The Citation Twelve/Citation Twelve Deluxe

Technical Manual

ADDENDUM TO CITATION TWELVE TECHNICAL MANUAL

REVISED SECTION

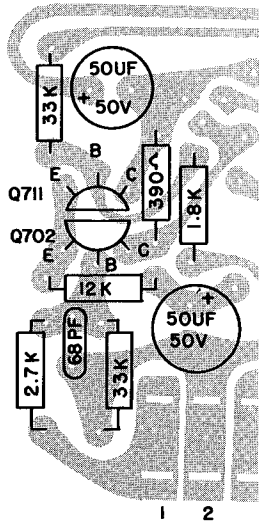
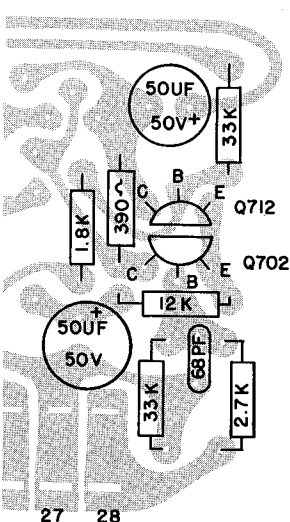
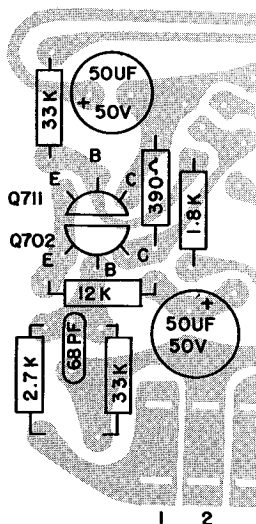
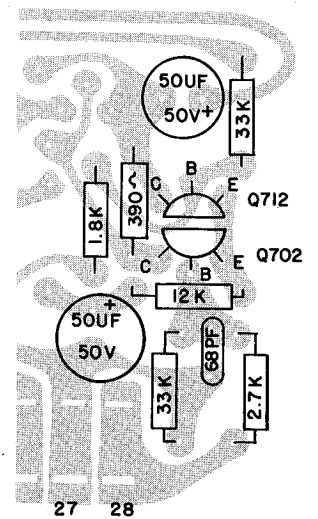
NOTE: ALSO SEE REVISED SECTION ON
P.C. BOARD (PAGE 4 & 5)

REVISED SCHEMATIC SECTIONS

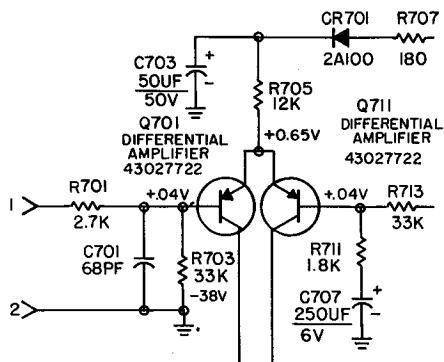
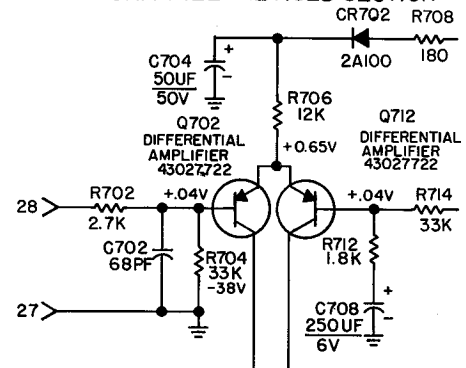
CIRCUIT REF.	DESCRIPTION	HK PART NO.	DESCRIPTION	HK PART NO.
DIODES				
CR7, CR8	Rectifier, Full Wave Bridge	41027230	FUSES AND CIRCUIT BREAKER	
			Fuse, Line 3A-3AG	45013291
TRANSISTORS				
Q701, Q702	Differential Amplifier	43027722	MISCELLANEOUS	
Q711, Q712	Differential Amplifier	43027722	Fuse Holder w/Hardware	65427001
			Line Cord	53026355
			Rubber Foot	62011692
RESISTORS				
R705, R706	Carbon Comp. 12K $\pm 10\%$ $\frac{1}{2}$ W	33311231 <i>70L</i>

REVISED TRANSISTOR CHART *5087*

Q NUMBER	H.K. PART NUMBER	COMMERCIAL EQUIVALENT
701, 702	43027722	2N5807 <i>5087</i>
703, 704	43024306	RCA 40408
705, 706	43024219	RCA 40595
707, 708	43023221	2N5232
709, 710	43024218	RCA 40594
711, 712	43027722	2N5807
1,2,3,4	43024216	RCA 40636

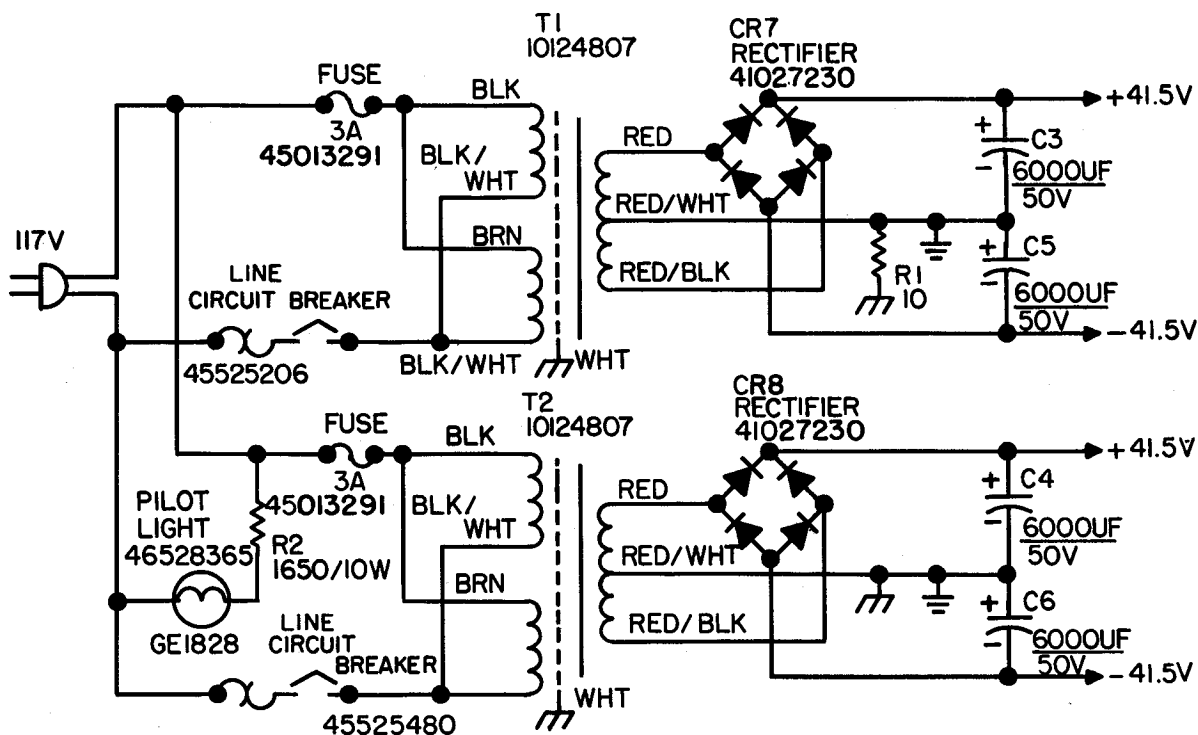
Line 2 add R2 1.65K 10W 10% 36928630

Line 3 change to R3-R700 not used

2. The schematic on page 3 is modified as shown below.
